Access Compliance Report

Public Rights-of-Way

(Curb Ramps)

Intersection ID: 14393	Main Street: BERKELEY_AV	Cross Street: LEXINGTON_AV	Location: SE
ADA ID: 73D035645584	Ramp Type: Perp	Initial Pass/Fail: Fail	Overall Compliance: No
Severity Score: 1.25			
Codes/Mitigation Info/Possible Solution		Field Measurements/Component Compliance

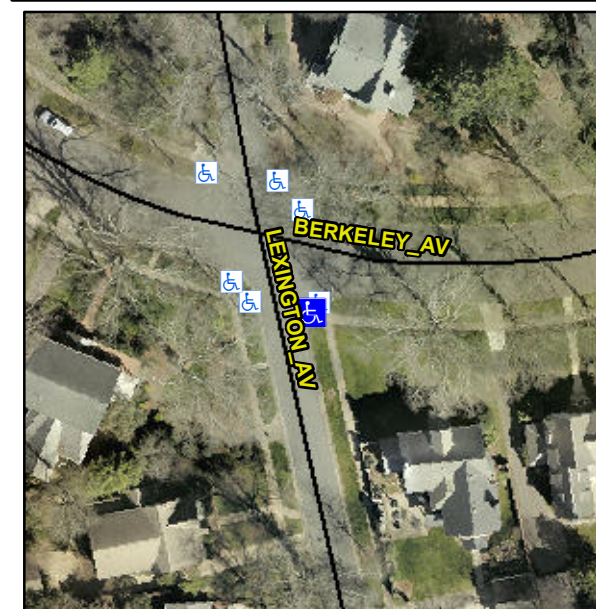
Not Found, R304.5.3

Compliance	Description	Data	Compliance	Description	Data
N/A	Ramp Length (in)	27.0	Yes	Ramp Slope (%)	6.7
Yes	Ramp Width (in)	62.0	No	Ramp XSlope (%)	3.3
N/A	Flare Type LT	N/A	N/A	Flare Type RT	N/A
N/A	Flare Slope LT (%)	N/A	N/A	Flare Slope RT (%)	N/A
N/A	Flare Traversable LT?	N/A	N/A	Flare Traversable RT?	N/A
N/A	Landing Length (in)	N/A	N/A	DWS Provided?	N/A
N/A	Landing Width (in)	N/A	N/A	DWS Contrast?	N/A
N/A	Landing Slope (%)	N/A	N/A	DWS Length (in)	N/A
N/A	Landing X Slope (%)	N/A	N/A	DWS Full Width?	N/A
N/A	Landing Curb? (Y/N)	N/A	N/A	DWS Offset (in)	N/A
N/A	Shared Landing?	N/A			
N/A	Gutter Ponding?	N/A	N/A	Gutter Slope (%)	N/A
N/A	Gutter Lip Ht (in)	N/A	N/A	Gutter X Slope (%)	N/A
N/A	Painted X Walk1?	No	N/A	Painted X Walk2?	N/A
	X Walk 1 Direction	To W		X Walk 2 Direction	N/A
N/A	X Walk 1 Width (in)	N/A	N/A	X Walk 2 Width (in)	N/A
	X Walk 1 Slope (%)	9.8		X Walk 2 Slope (%)	N/A
	X Walk 1 X Slope (%)	1.4		X Walk 2 X Slope (%)	N/A

Remove & Replace Entire Ramp.
